STATE OF NORTH CAROLINA
DEPARTMENT OF TRANSPORTATION

ADDENDUM # 1

RE: **Pay Item Addition, SP Addition, Roadway Plan Revision,
Structure Plan Revision**
Contract ID: DN00132
County: Macon
Letting Date: February 8, 2022

**LOCATION: BRIDGE NO. 343 OVER ALLISON CREEK
 ON SR 1448 (WEST OLD MURPHY ROAD)**

| PROJECT REFERENCE NO. 14SP.205611 | | SHEET NO. 4 |

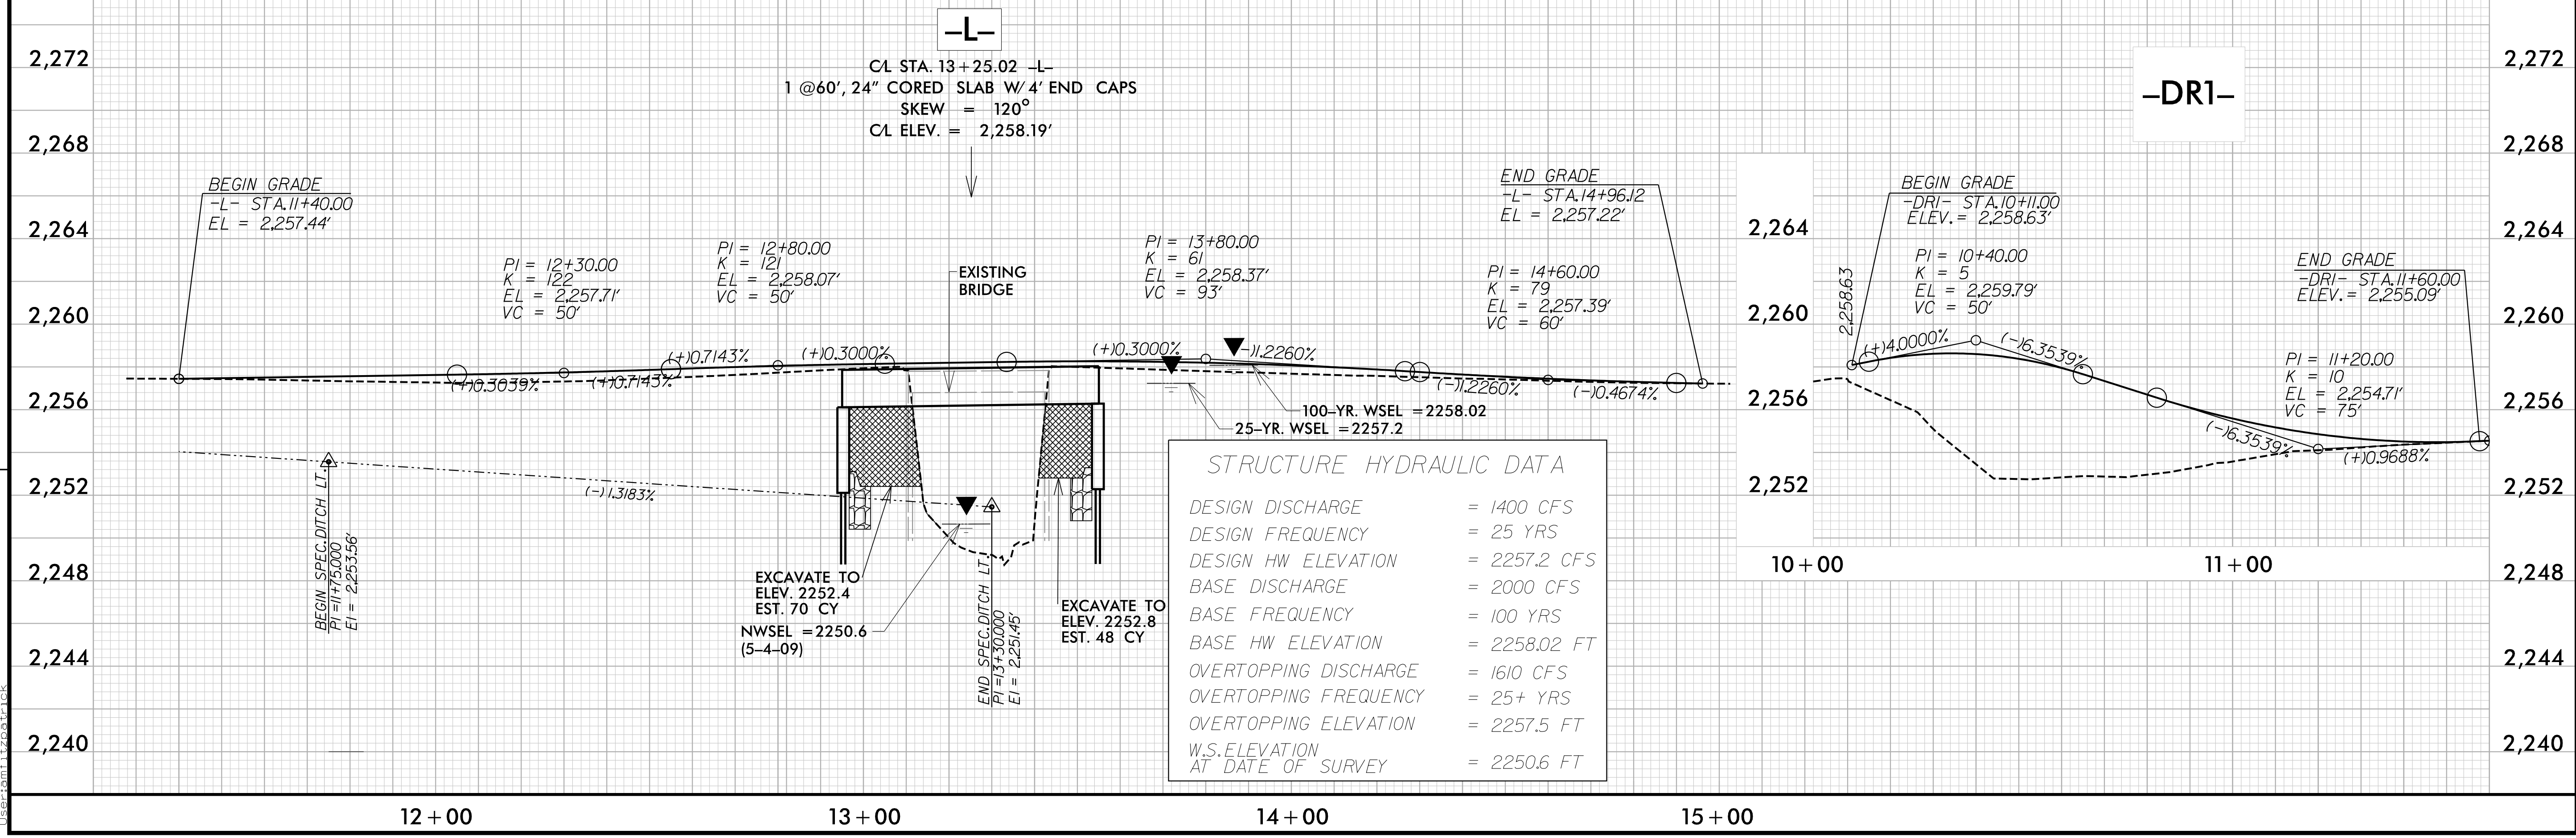
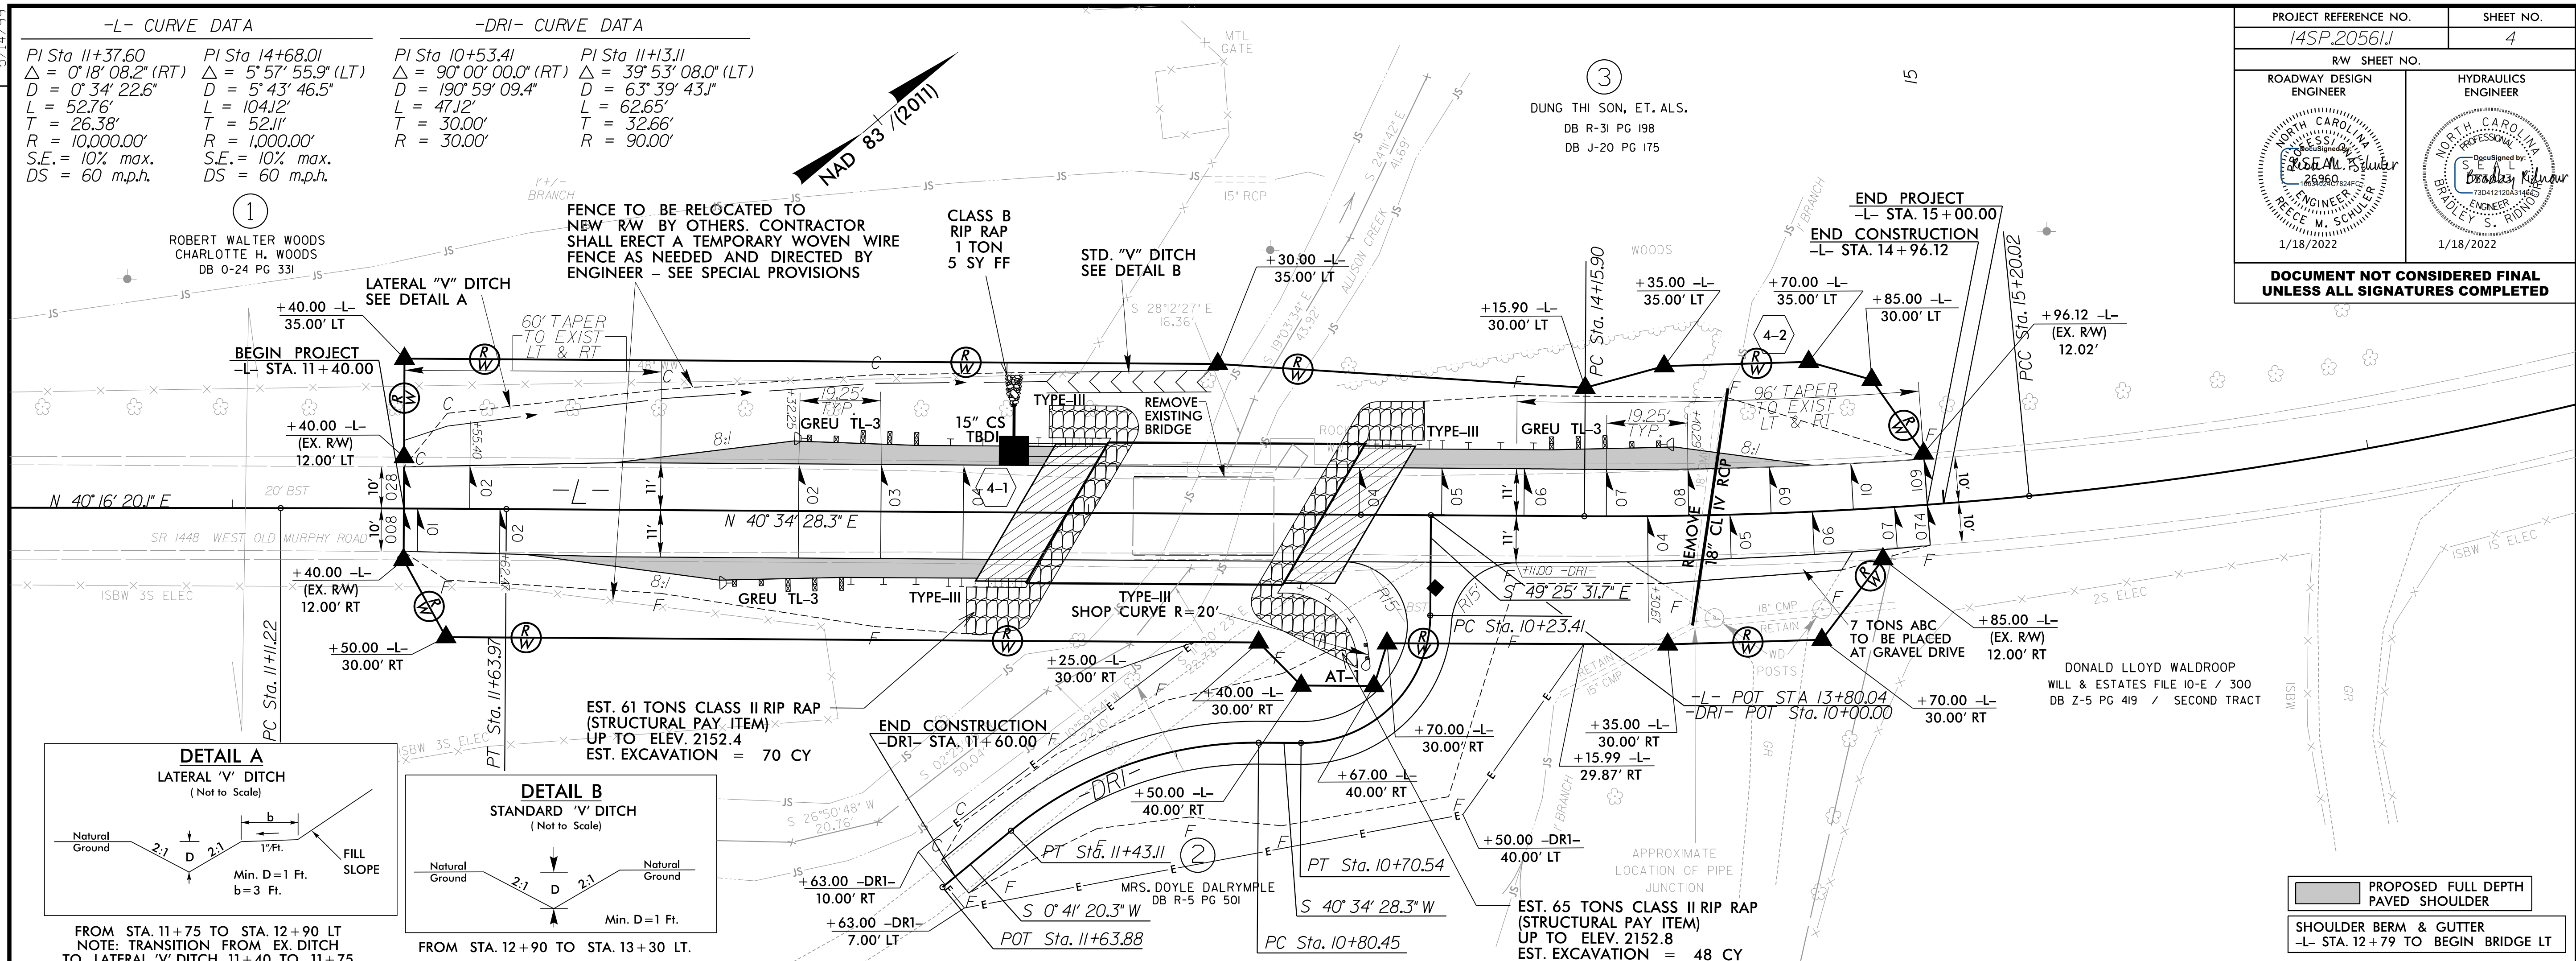
Sheet 4 of the roadway plans has been revised to show the addition of the Temporary Woven Wire fence item.

SECTION AT END BENT
 FOR EXTERIOR SLABS

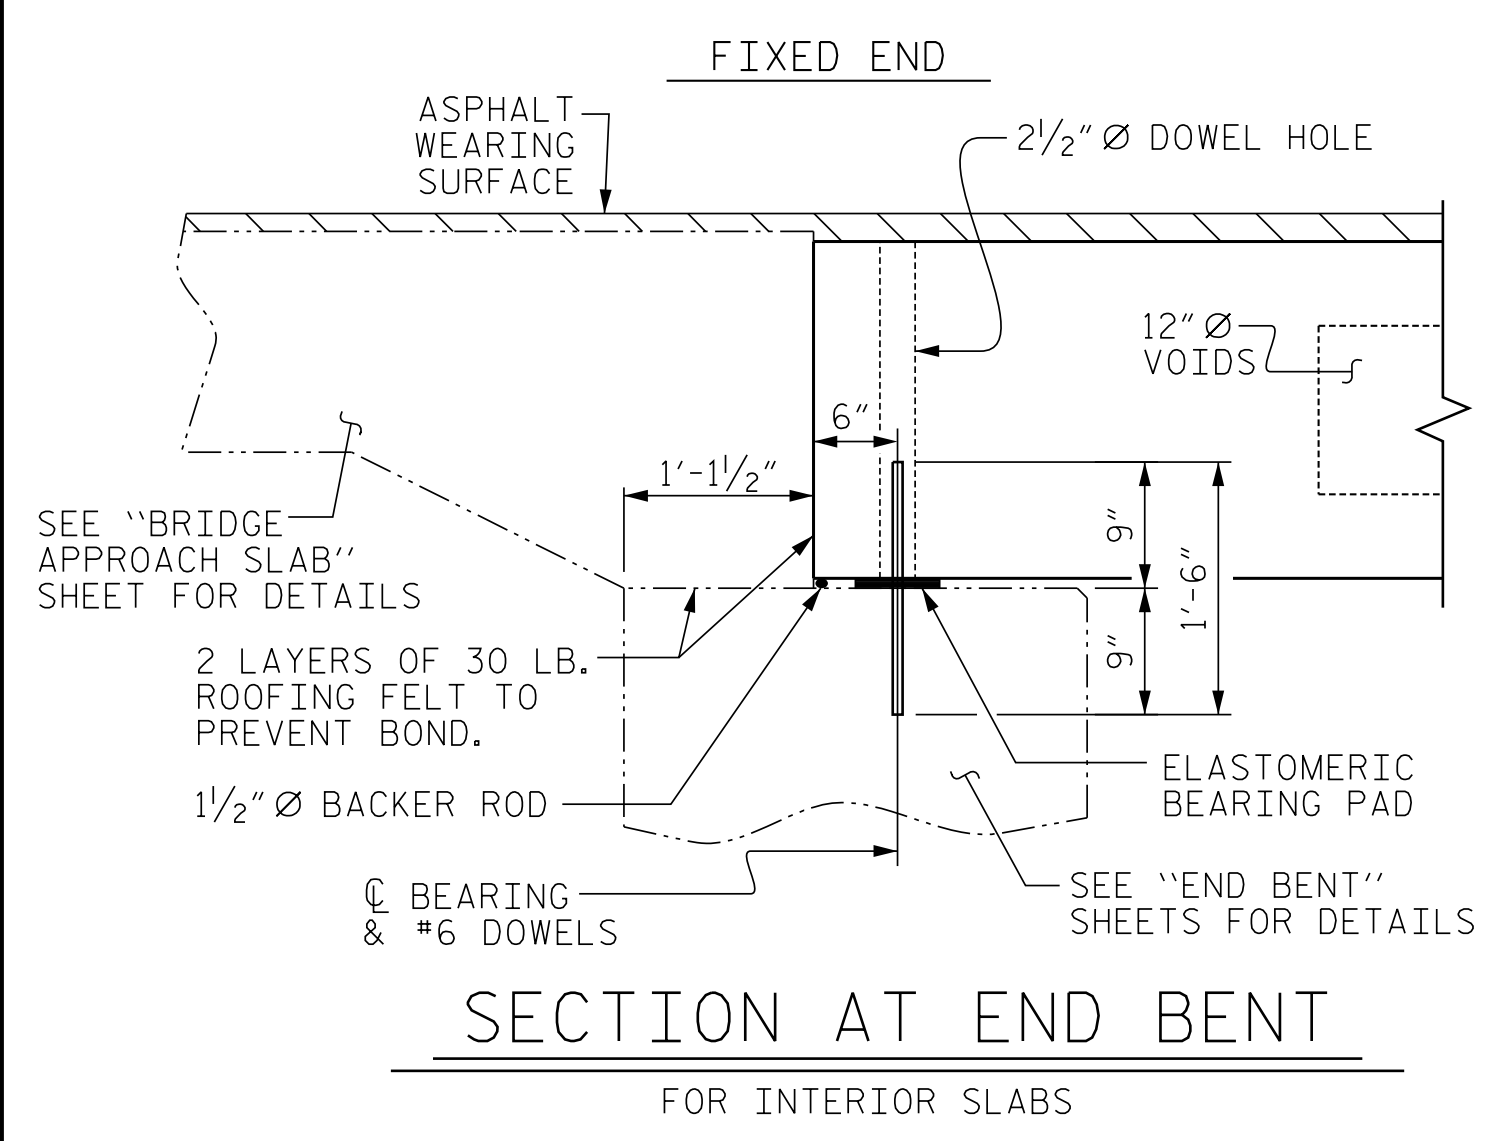
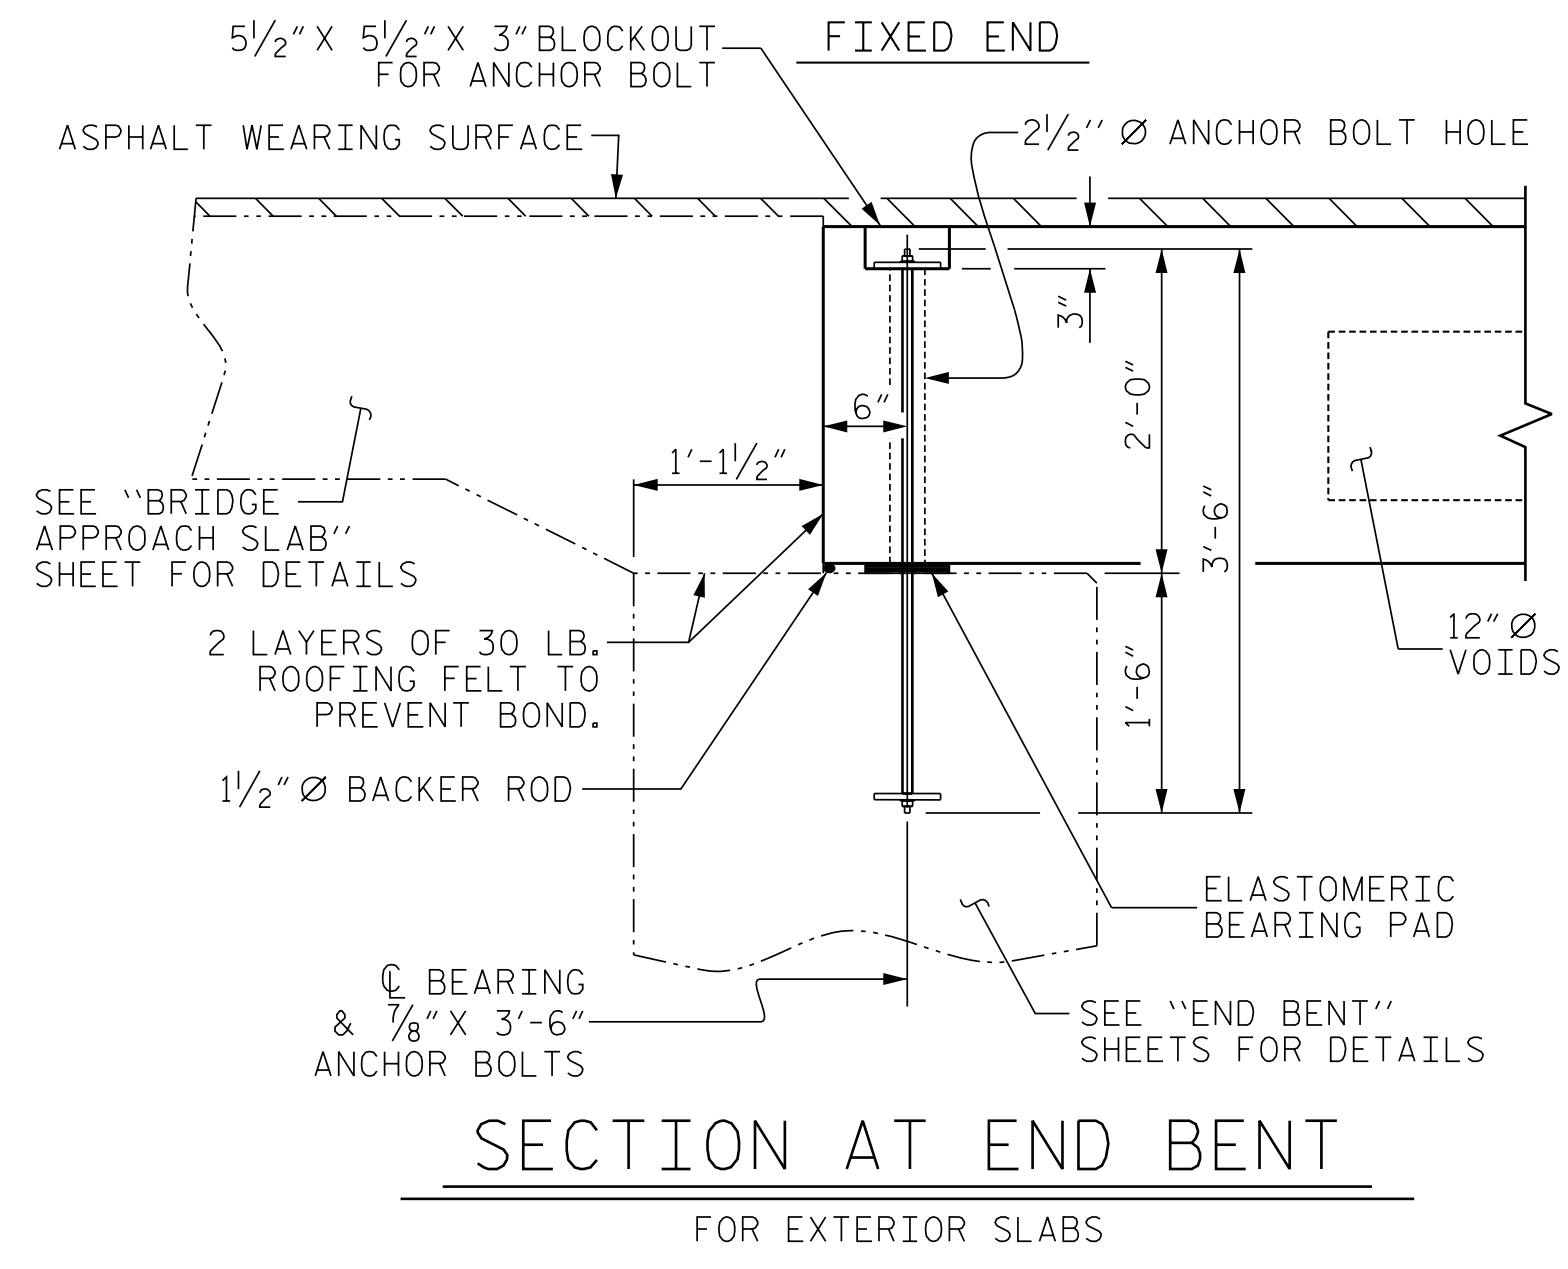
The structure plans have been revised to show the exterior cored slabs bolted down instead of connected to the cap with a dowel.
